## ***Ventilation Control In Terminal Units With Variable Speed Fan Control***

By: John Murphy, an applications engineer with Trane, La Crosse, Wisconsin  
ASHRAE Journal, December 2013 pages 12-19

### **Comments January 17, 2014**

**by: Dr. S. A. Mumma,**

FIGURE 3 Conditioned OA delivered to the inlet of each terminal unit.

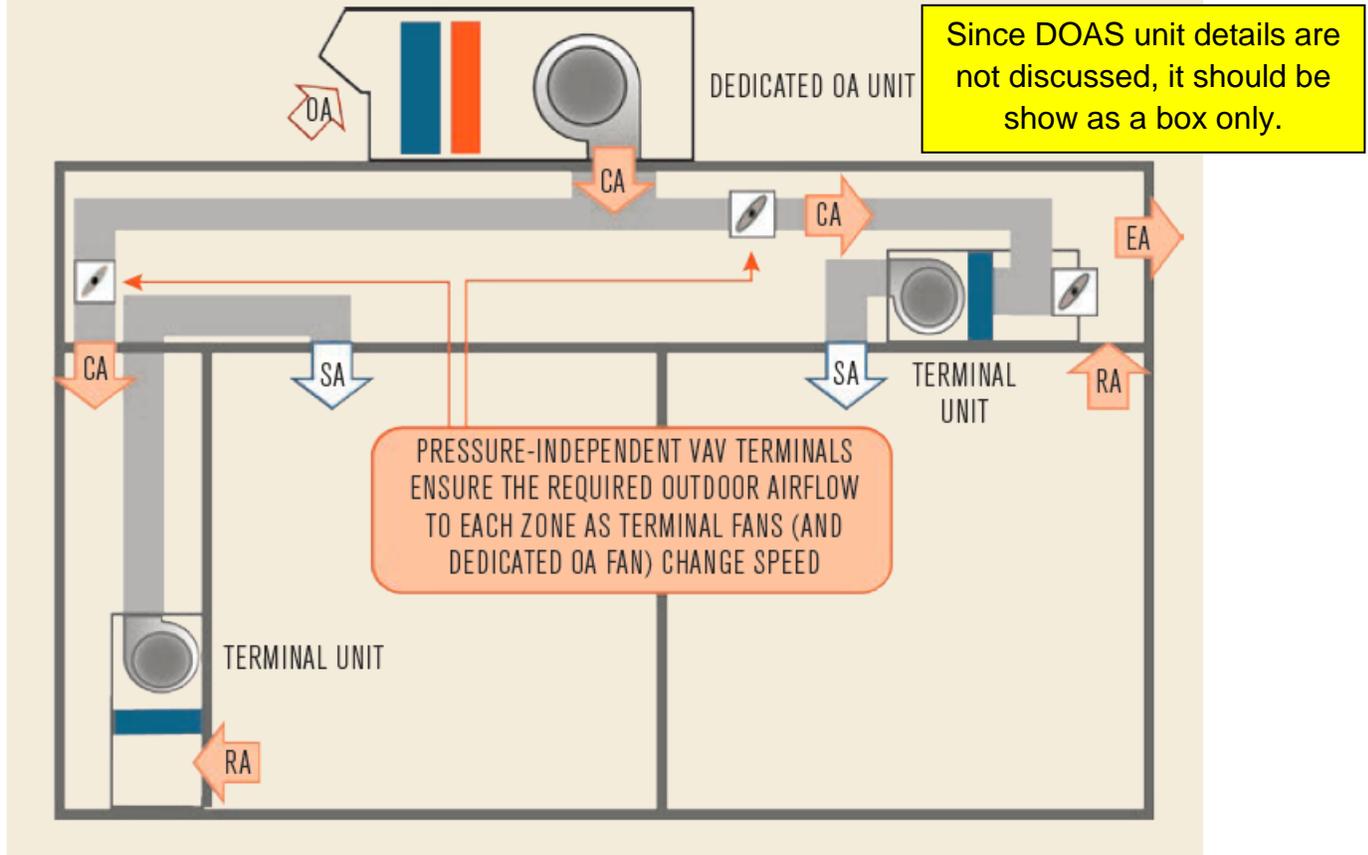
Article Figure 3 below should be selected only as a last resort. The arrangement is made thermodynamically inefficient by placing terminal unit cooling coils in **series** with the DOAS unit CA supply.

FIGURE 4 Conditioned OA delivered directly to each zone.

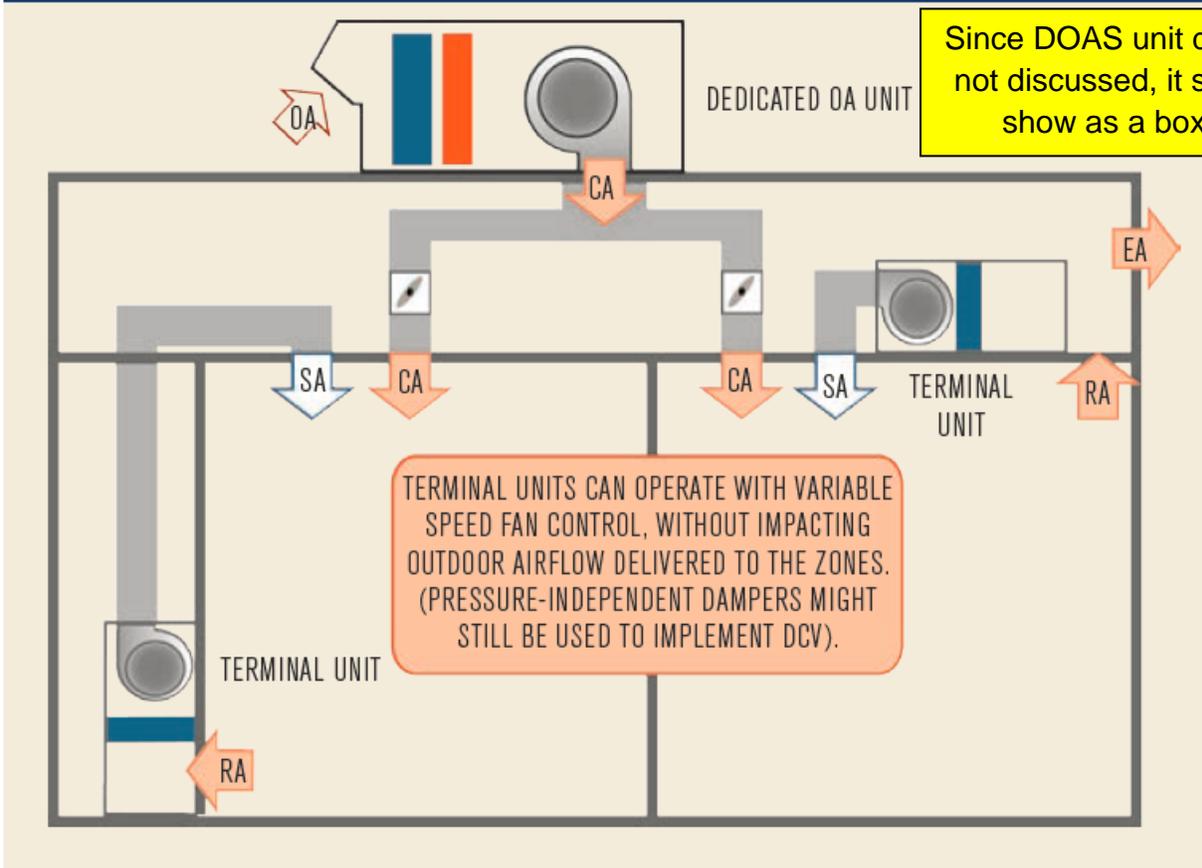
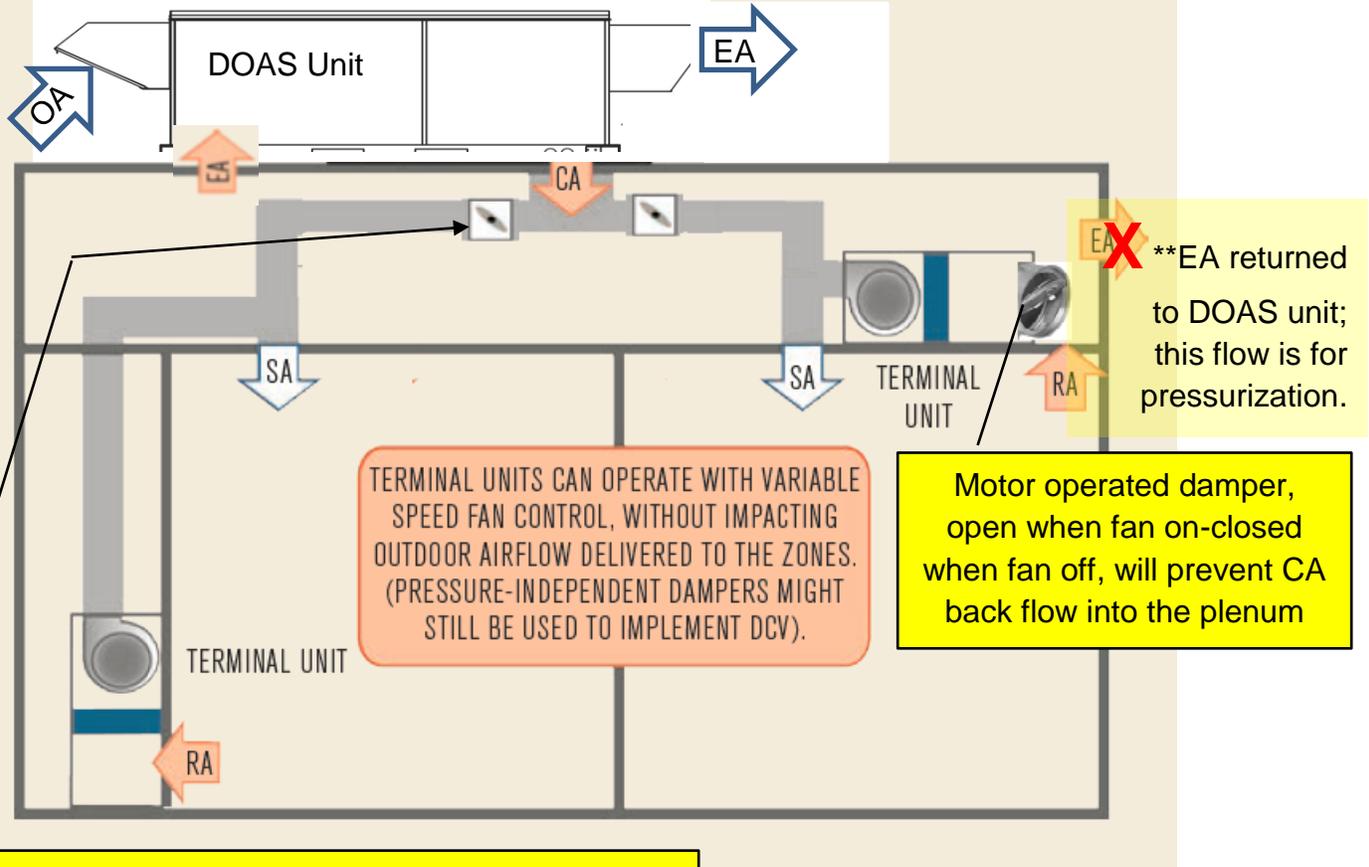
In an effort to rectify the inefficiencies of the series arrangement, the author included Figure 4 below in the article. This is a fine arrangement, but for small spaces the arrangement often makes extra diffuser placement problematic. Unfortunately, the author did not illustrate how to achieve parallel DOAS CA and terminal coil placement and overcome the problematic diffuser issue. Mumma has added below a “Modified” Figure 4 illustrating how this can be achieved.

Mumma Modified Fig. 4: DOAS CA delivered to terminal unit discharge

Need not be VAV boxes. Control dampers must have authority over full range of CA flow. For acoustical reasons position back from diffusers.

Note: An alternative to “pressure independent” is “flow (i.e. thermal dispersion) measurement” controlled dampers.
